Re: Former Tidewater Service Station 373378  
7600 MacArthur Boulevard  
Oakland, California

**Re: Updated Site Conceptual Model and Data Gap Work Plan  
Former Tidewater Service Station  
Phillip 66 Site 5677/Chevron Site 373378  
7600 MacArthur Boulevard  
Oakland, California  
ACDEH Fuel Leak Case No. RO3087**

Subject: Technical Report Request for Fuel Leak Case RO0003087 and GeoTracker Global ID T10000003434, Hong Gardner Property, 7600 MacArthur Boulevard, Oakland, CA 94605-2944

Attachment 2, *Sample Figures of Adjacent Buildings with Basements, LTCP Plume Lengths, and Well Survey*

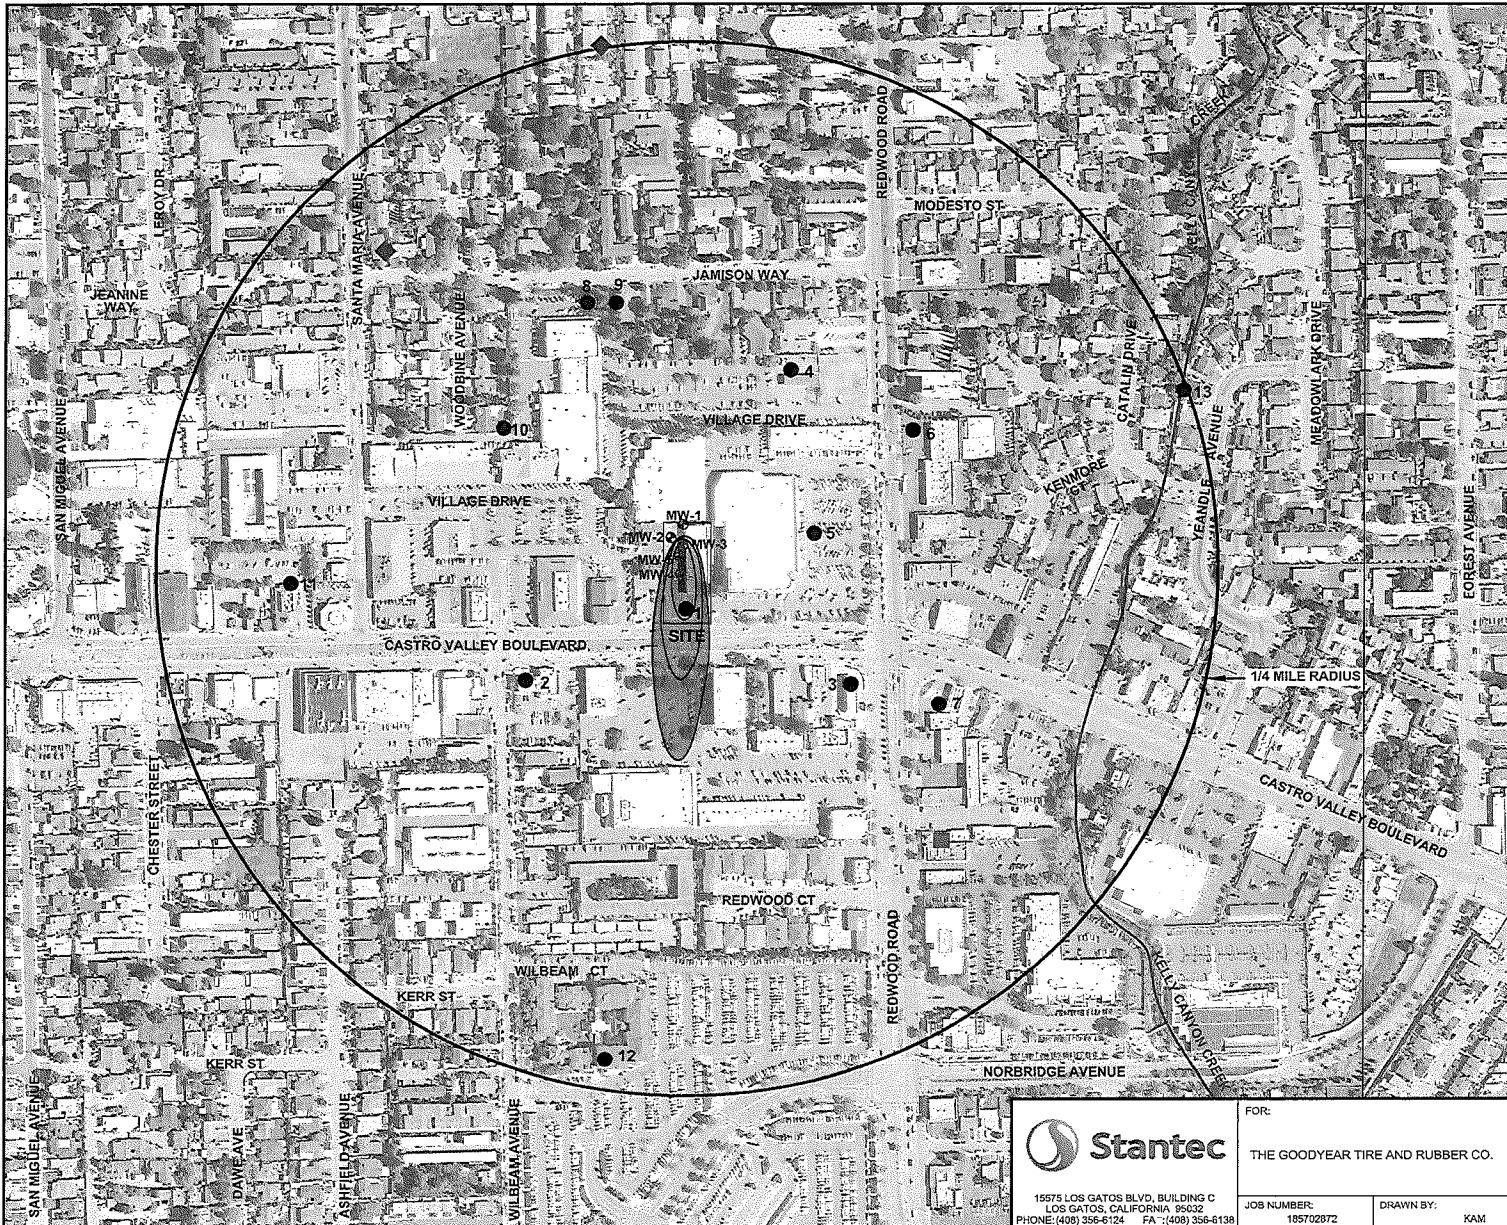
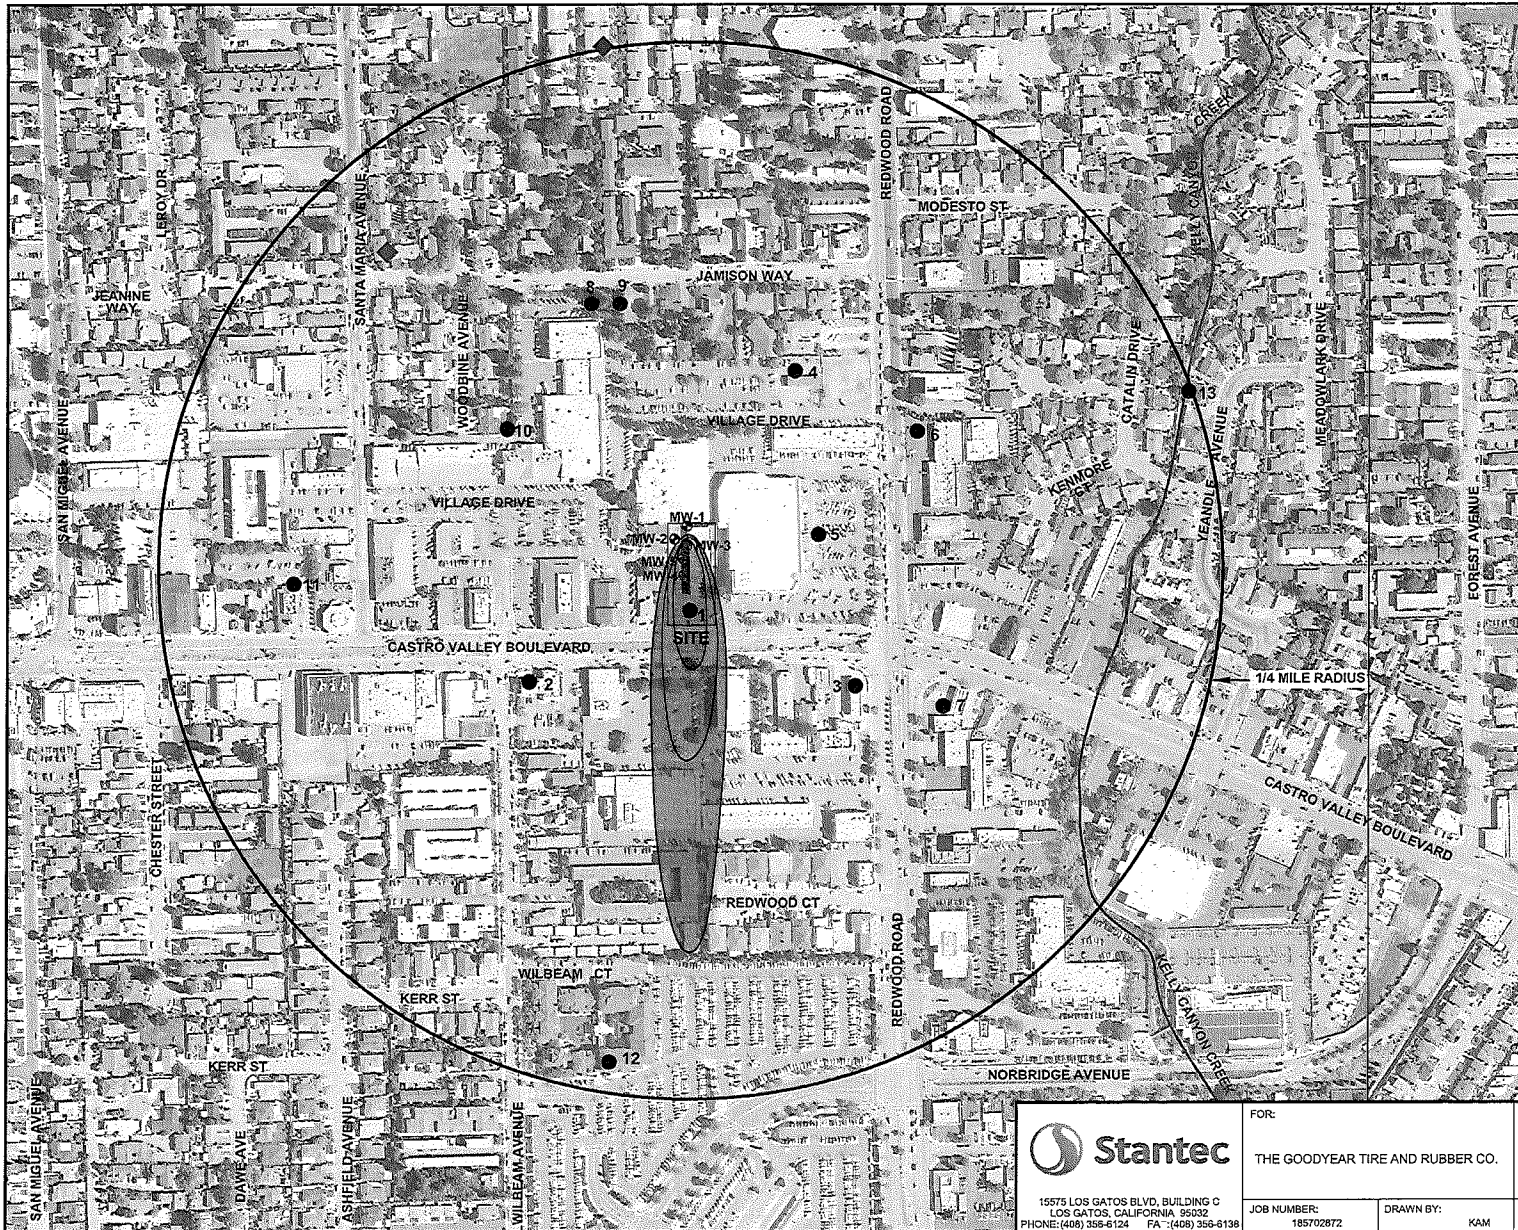
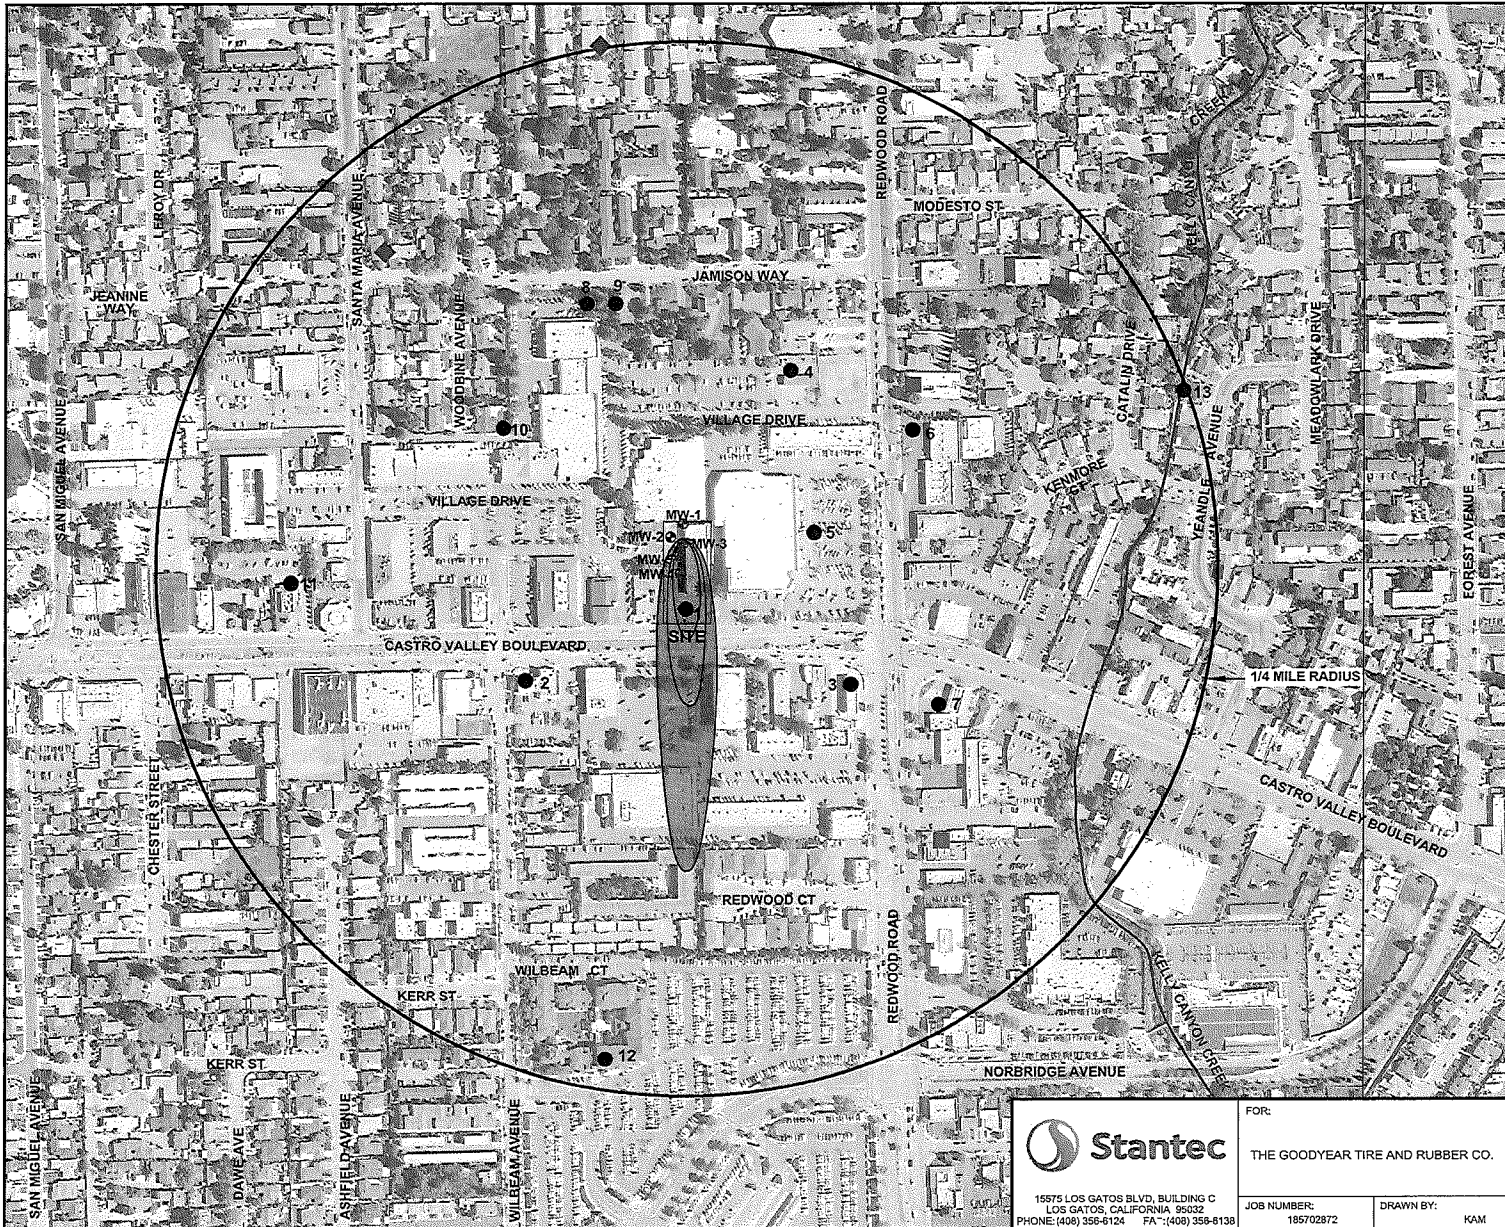
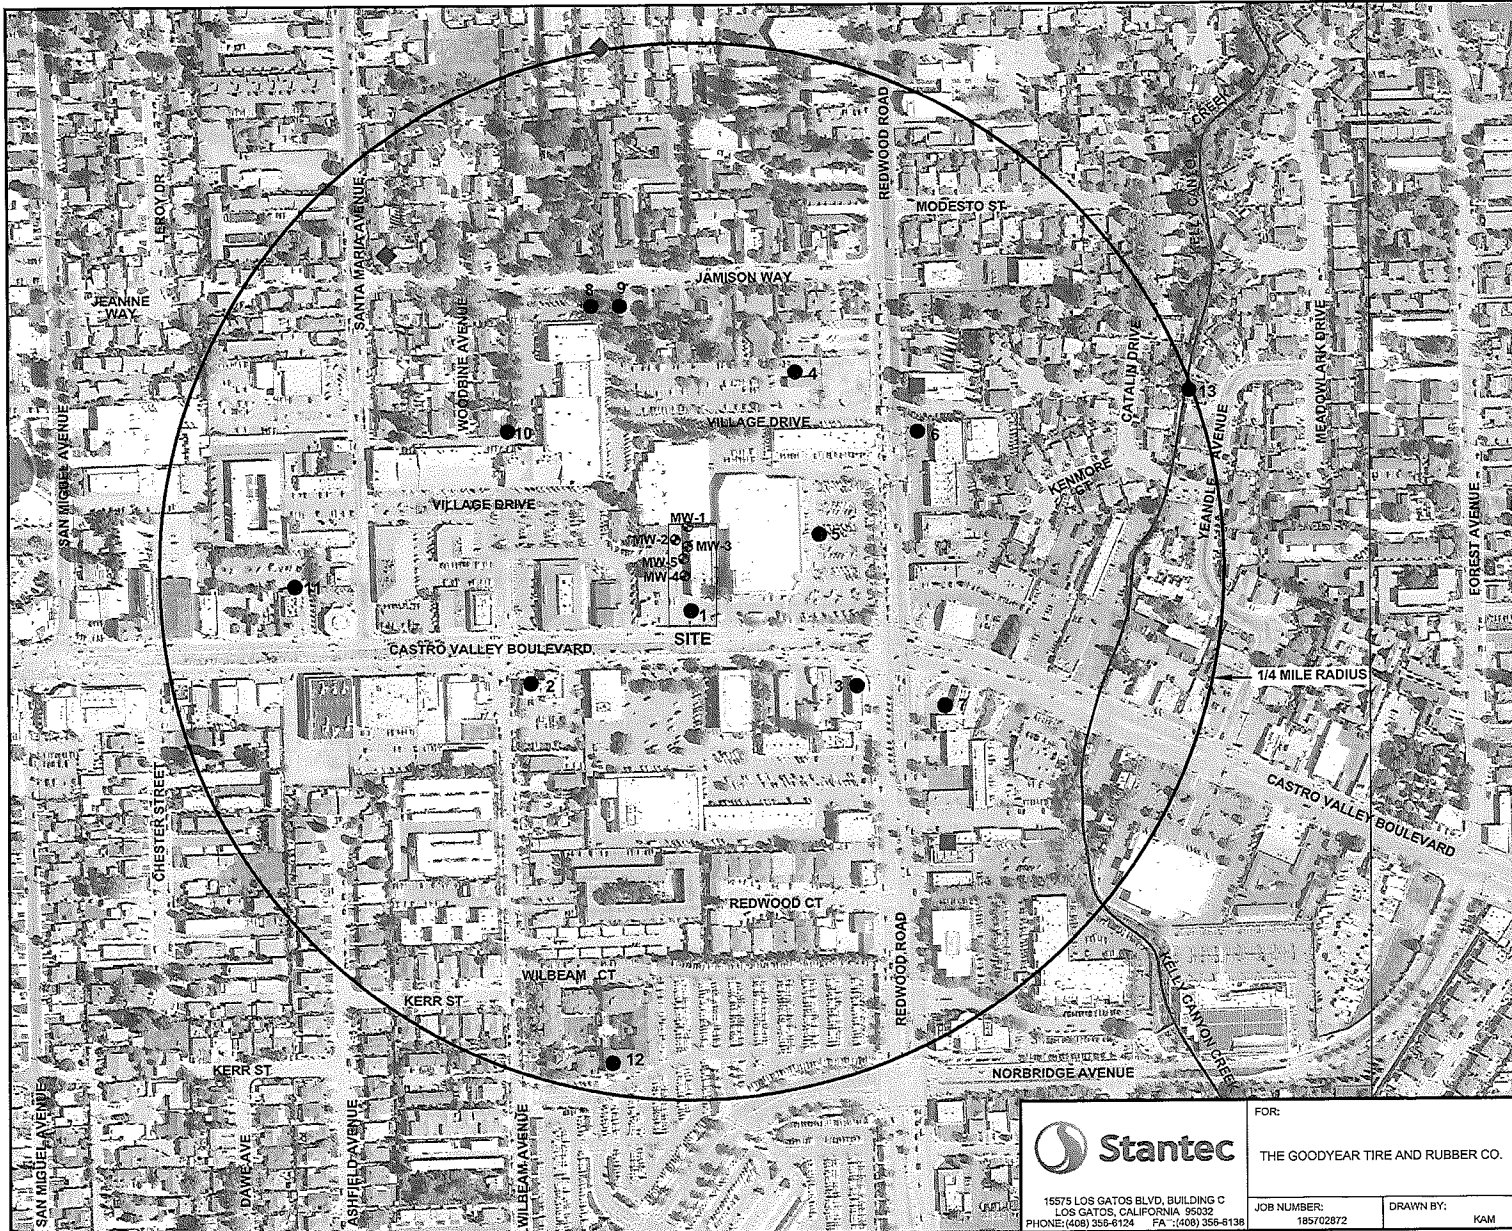
- d. **LTCP Plume Lengths:** To present another line of evidence supporting plume lengths, please prepare a figure indicating the average, 90<sup>th</sup> percentile, and maximum plume lengths for TPHg, benzene, and MTBE by referencing Table 1: *Plume Characteristics*, in the LTCP's *Technical Justification for Groundwater Media-Specific Criteria*. As shown in Attachment 2, *Sample Figures of Adjacent Buildings with Basements, LTCP Plume Lengths, and Well Survey*, please include the locations of the six water production wells identified in the one mile well survey included in the Report.

As a part of updating the SCM, please include a rose diagram and locations of houses and buildings that have basements in the immediate downgradient direction of the site similar to the example provided in Attachment 2, *Sample Figures of Adjacent Buildings with Basements, LTCP Plume Lengths, and Well Survey*.
